TITLE: **USE PERMIT NO. 15005**
(Firethorn: South 84th & Van Dorn Streets)

LINCOLN/LANCASTER COUNTY PLANNING STAFF REPORT

PROJECT #: Use Permit #15005 - Firethorn Corporate Center

PROPOSAL: To allow a 225,000 square foot office park, that could alternately be developed as a 150-unit apartment complex

SITE PLAN

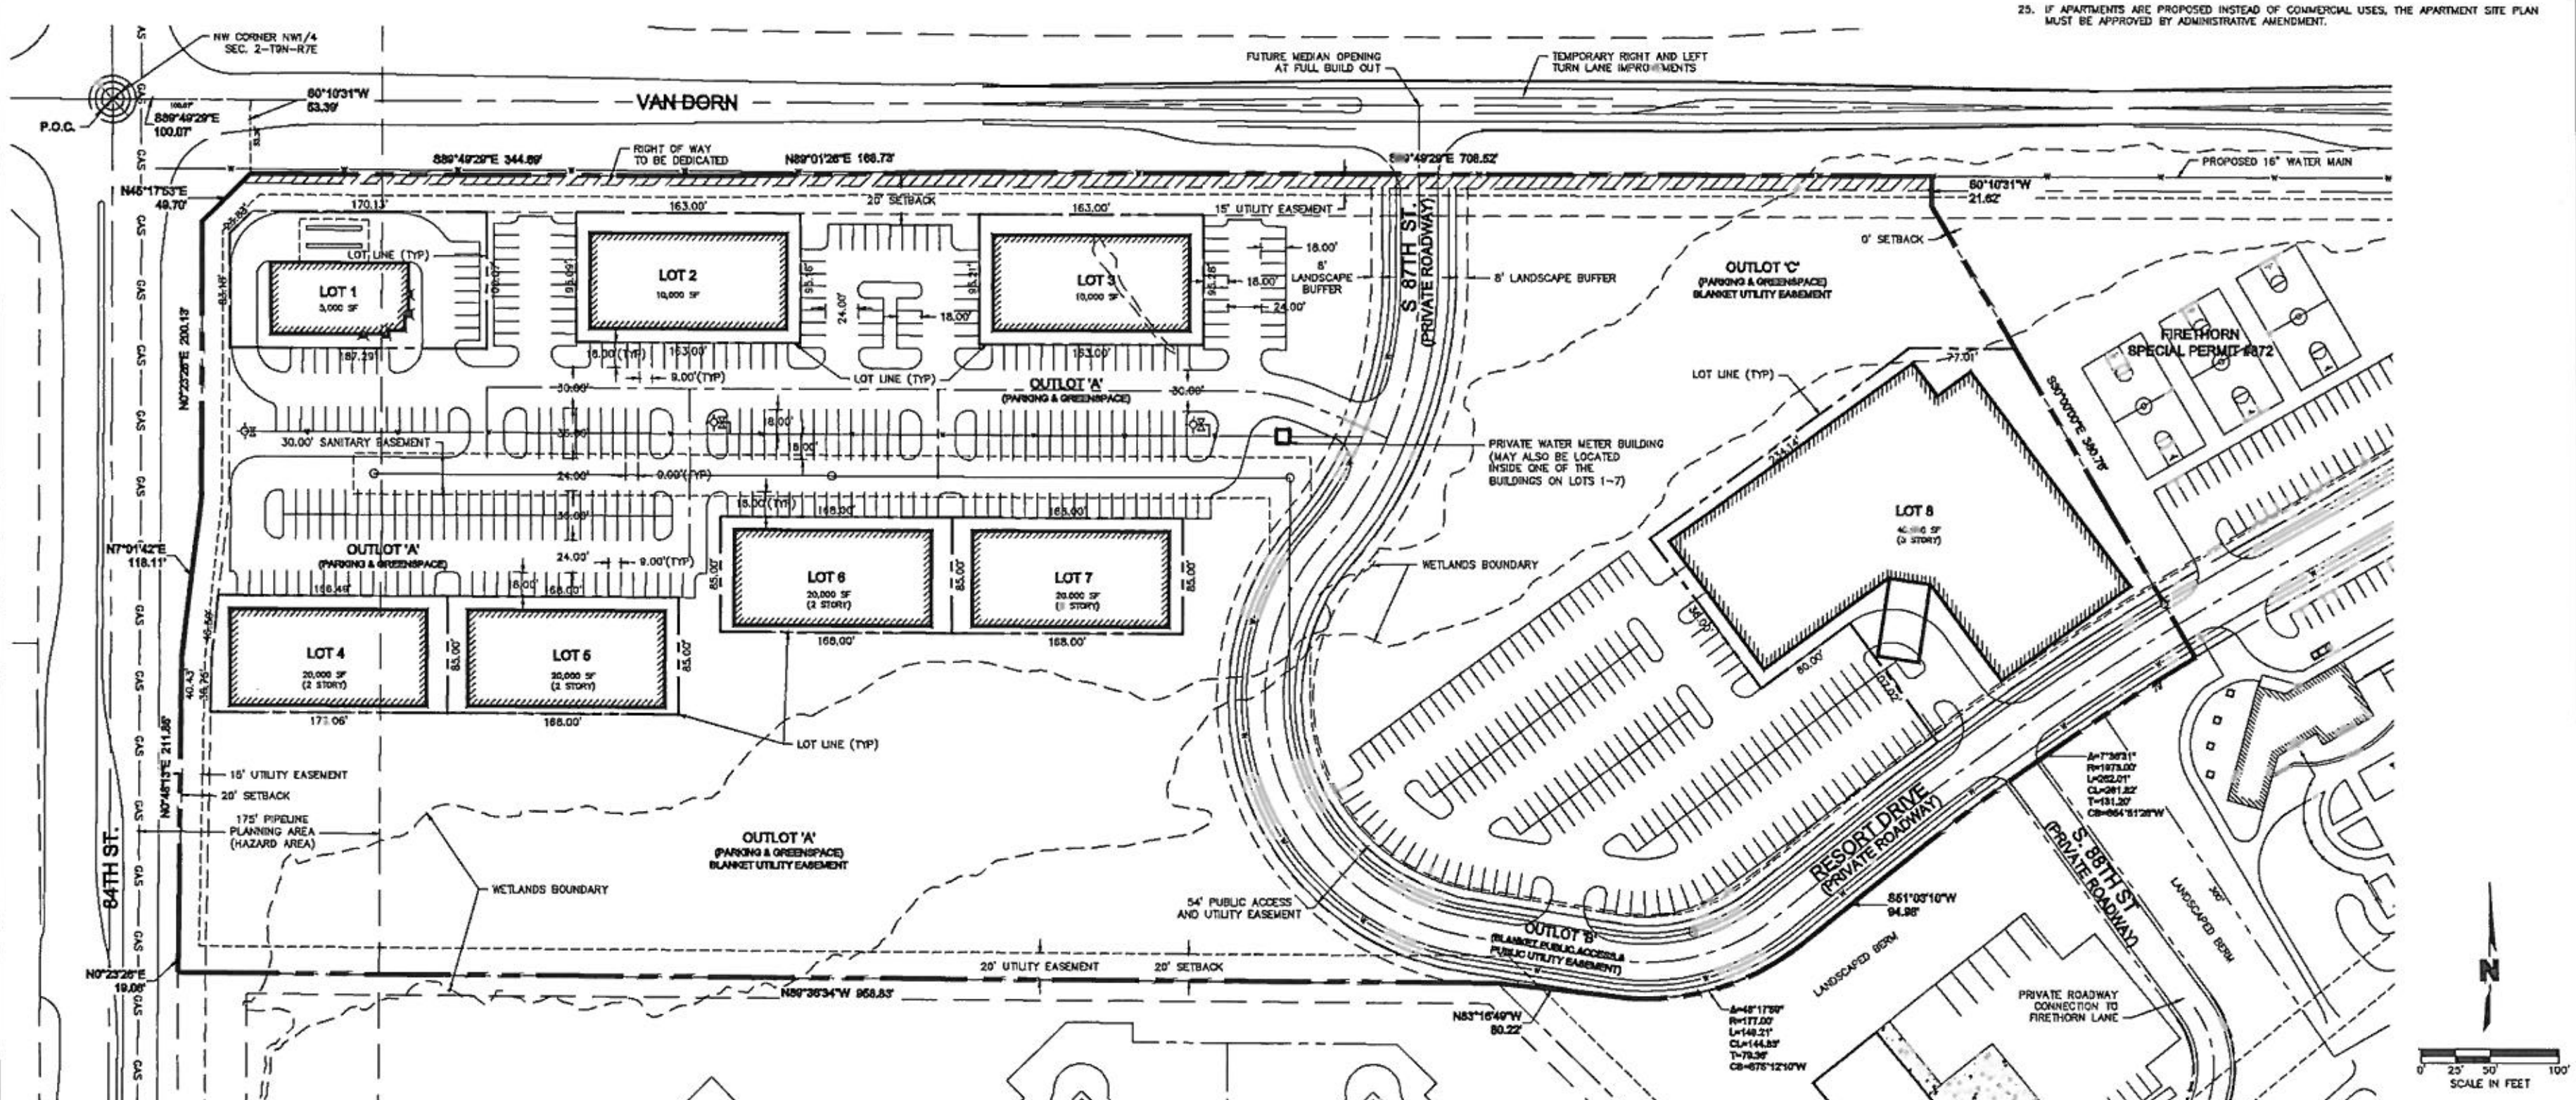
1.1 Revise the site plan to include a note which states "Front, side and rear setbacks for Lots 1-8 are adjusted to 0'. Setbacks are designated for Outlots A and C and are as shown on the site plan.

1.2 Add a note which states "Parking shown is conceptual, but to be provided in compliance with LMC at the time of building permit.

1.3 Revise Note #10 so the second line of the note reads "...SIGNS, LANDSCAPING, AND SCREENING SHALL COMPLY WITH THE O-3 ZONING DISTRICT AND SHALL BE SHOWN AT THE TIME OF..."

1.4 Delete the 'Parking Calculations' table.

1.5 Revise the note in the Waiver Table to state "The front, side and rear setbacks for Lots 1-8 are reduced to 0'.
